**BC Hydro  
Revenue Requirements Application  
F2012-F2014**

**Information Request #2**

**By: Ludo Bertsch, Horizon Technologies Inc.  
For: Energy Solutions for Vancouver Island Society  
Date: March 6, 2012**

**1.0) Colwood Area Reinforcement in RRA**

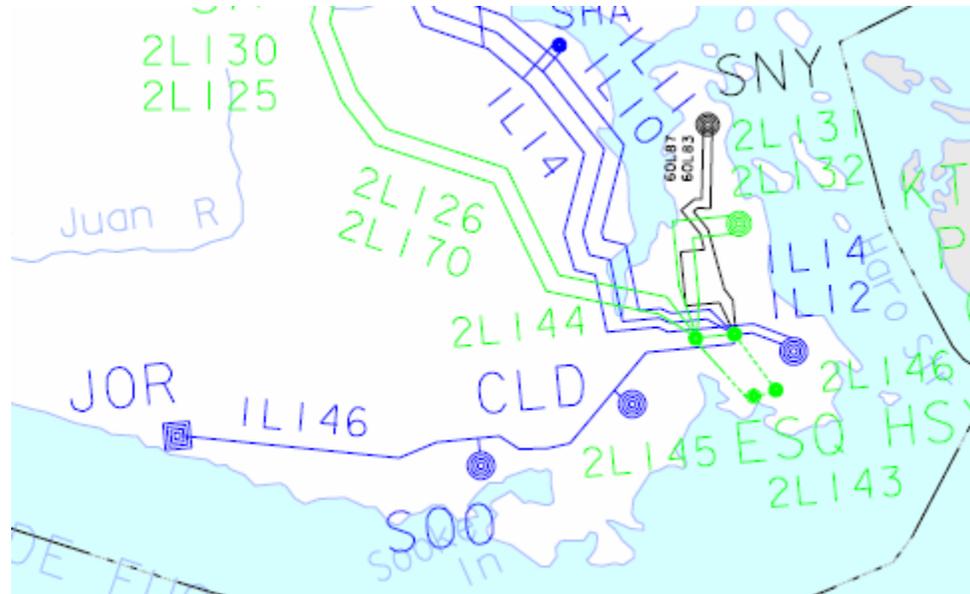
In the diagram below, BC Hydro identified circuit 1L146 between CLD and GOW, and 1L143 is shown between JOR and SOO<sup>10</sup>:

This shows a label of 1L146 between JOR and SOO instead of 1L143.

- 1.5.1 Please confirm the up-to-date labeling of the following sections - JOR-SOO, SOO-CLD, and CLD-GOW - and please update documents as appropriate.
- 1.5.2 Outages statistics were provided by BC Hydro for transmission line segment 1L146 in ESVI 1.1.9.2, but given the labeling discrepancies noted above, it is not clear for which transmission segment the statistics are provided. Please provide the same statistics as in ESVI 1.1.9.2 for each of the following sections: JOR-SOO, SOO-CLD and CLD-GOW.

- 1.5.3 The causes for outages were provided by BC Hydro for 1L146 in ESVI 1.1.9.3, but given the labeling discrepancies noted, it is not clear for which transmission segment the statistics are provided. Please provide the same statistics as in ESVI 1.1.9.3 for each of the following sections: JOR-SOO, SOO-CLD and CLD-GOW.
